DOCUMENT 00 91 13

Addendum Number Two

PROJECT: ITD D5 Maintenance Building Addition and
Renovation and New Brine Facility
Blackfoot, Idaho

PROJECT NO.: 22569

① TYPICAL ROOF DETAIL
 SCALE: 1 1/2" = 1'-0"

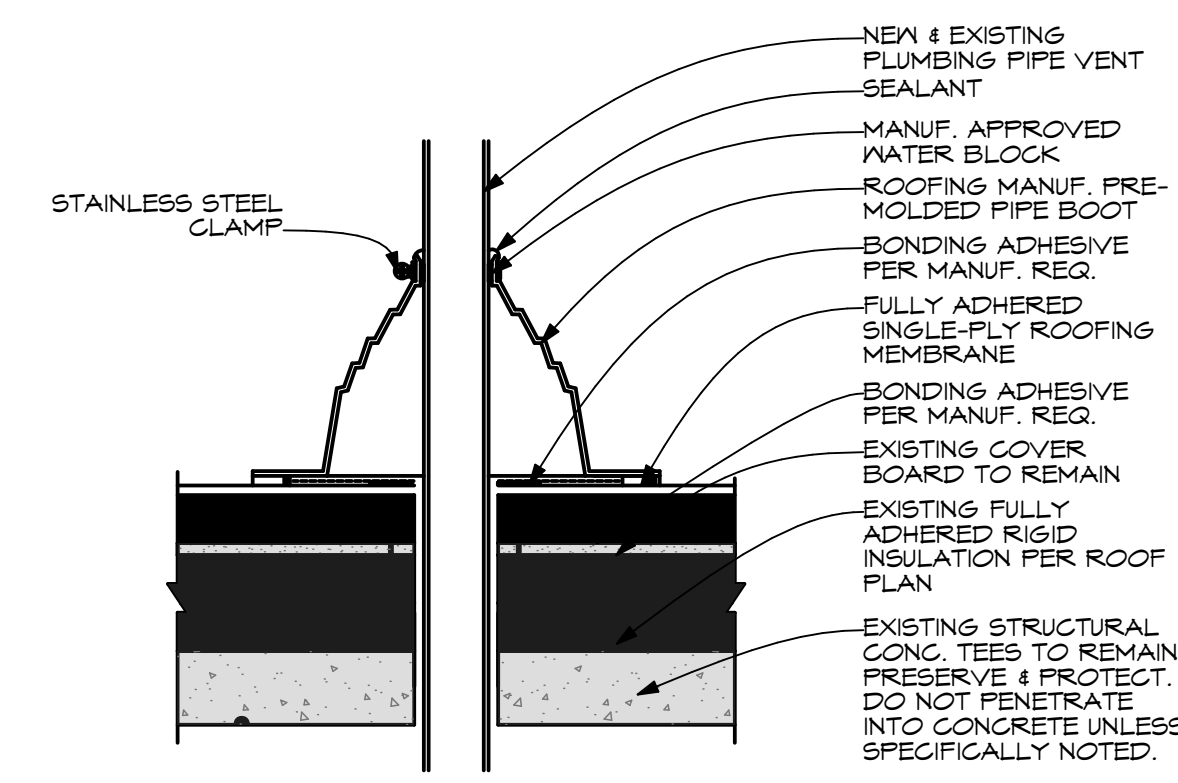
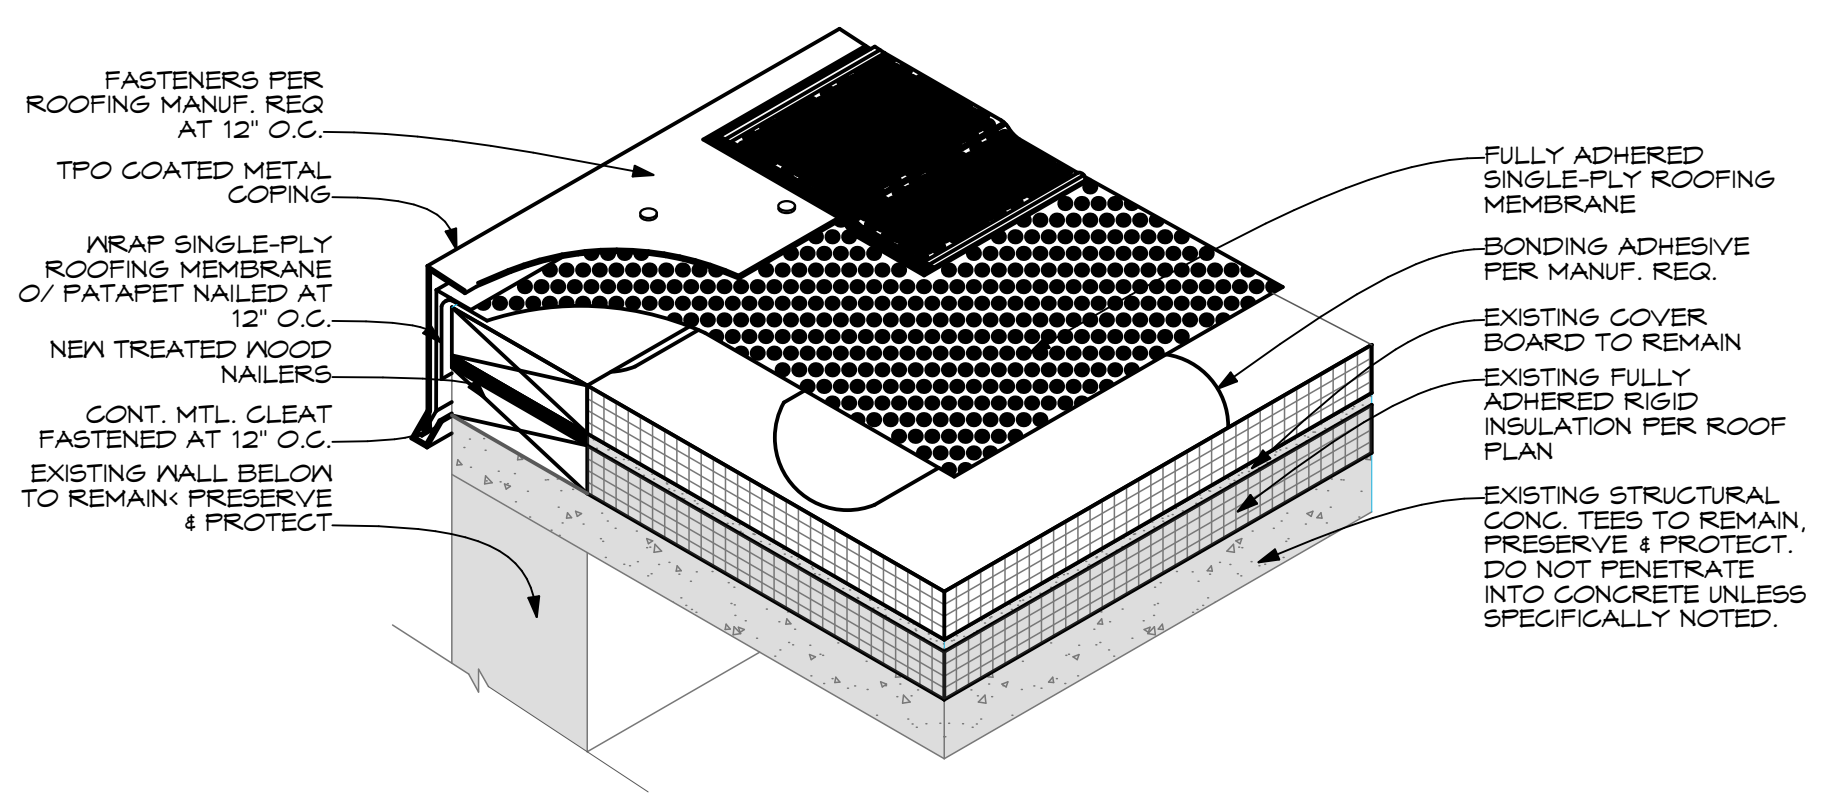
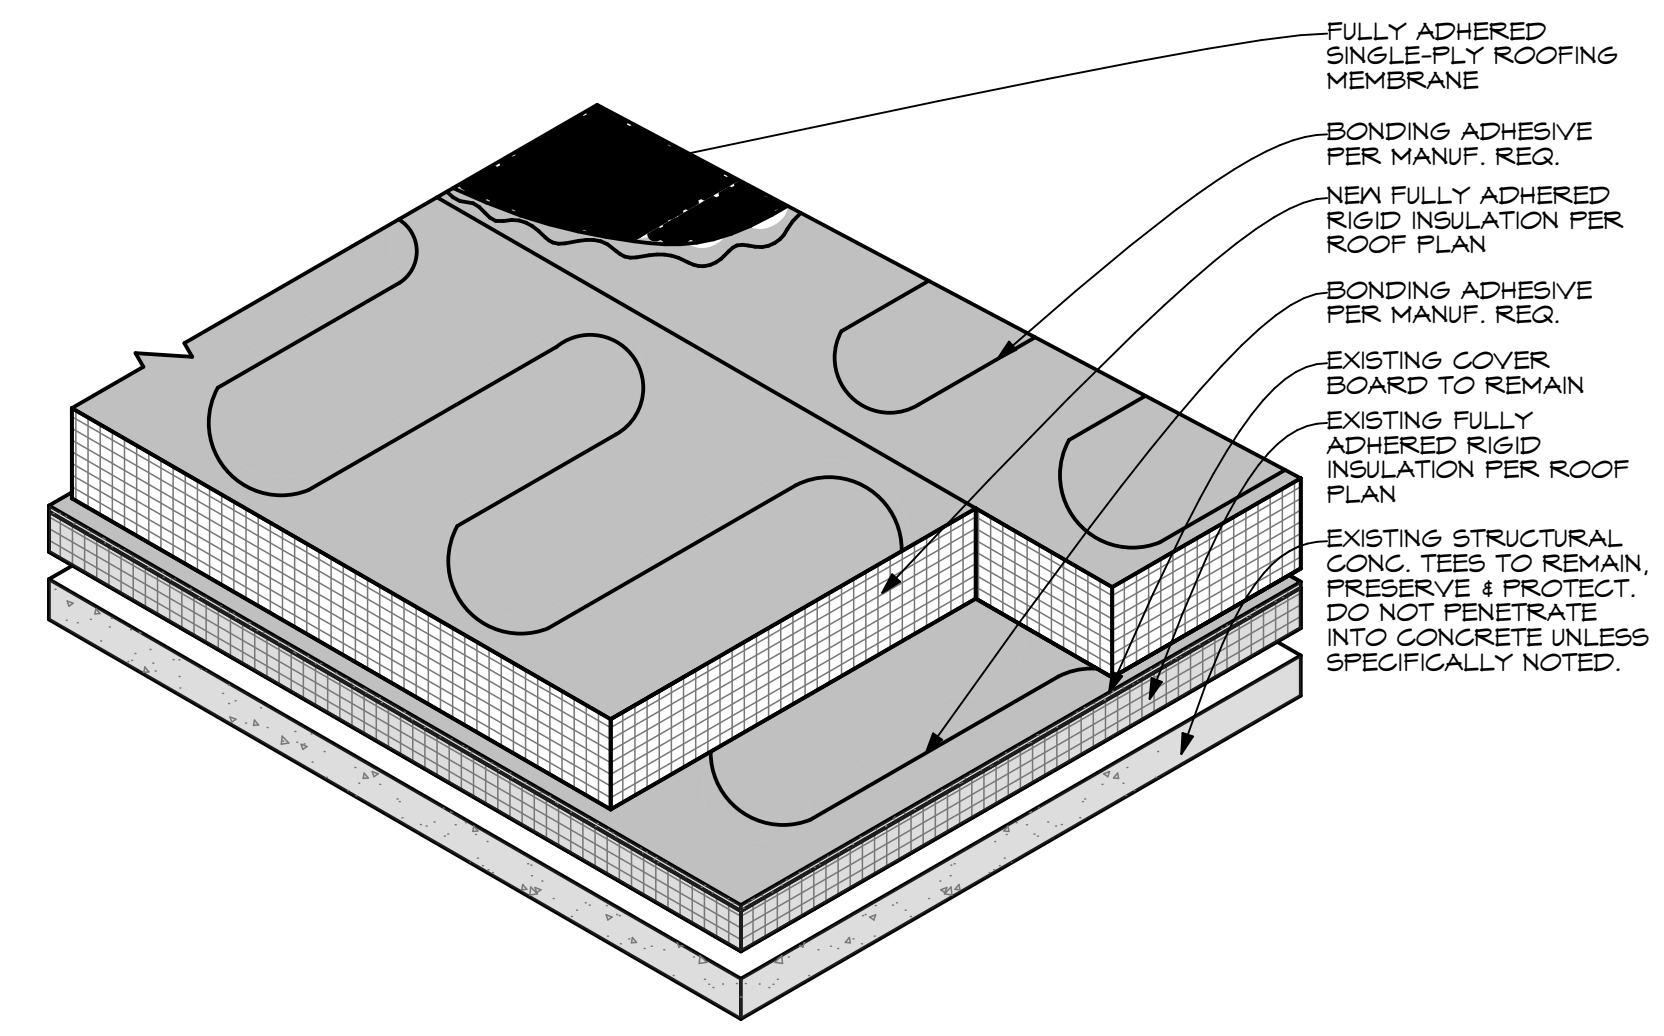
- a. Revised details 1, 2, and 3 on drawing sheet
 - b. Provided notes on plan for clarification of single-ply membrane and ballast removal.
4. Add Sheet A104.1 – Typical Roof Details.

- a. Provided typical roof details.
5. Sheet A400 – Door & Window Schedules, Elevations, and Notes.
 - a. On doors 114A and 114B add closer “C1” to each door.

1 PLUMBING DEMOLITION FLOOR PLAN
 PD100 SCALE: 1/8" = 1'-0"

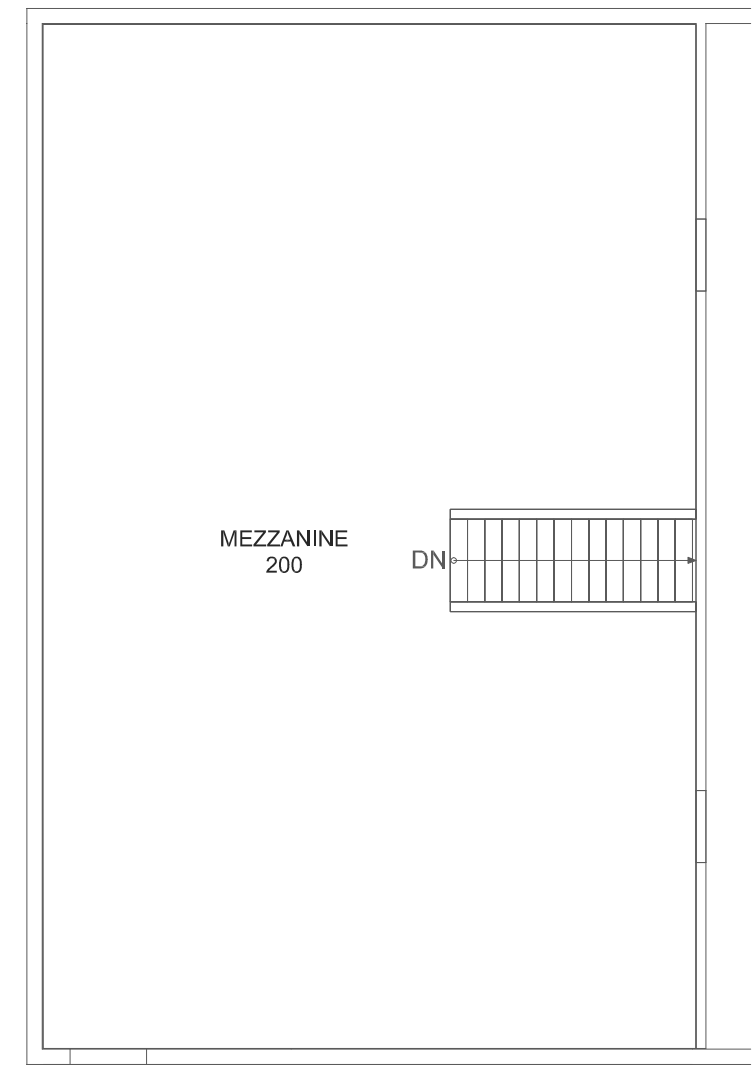
1. Replace Sheet PD100 – Plumbing Demolition Plan with attached Sheet PD100 – Plumbing Demolition Plan. Revisions are as follows.
 - a. Updated Keynote 10: “REMOVE NPCW LINE AND BACKFLOW DEVICE BACK TO MAIN. CAP AT MAIN.”
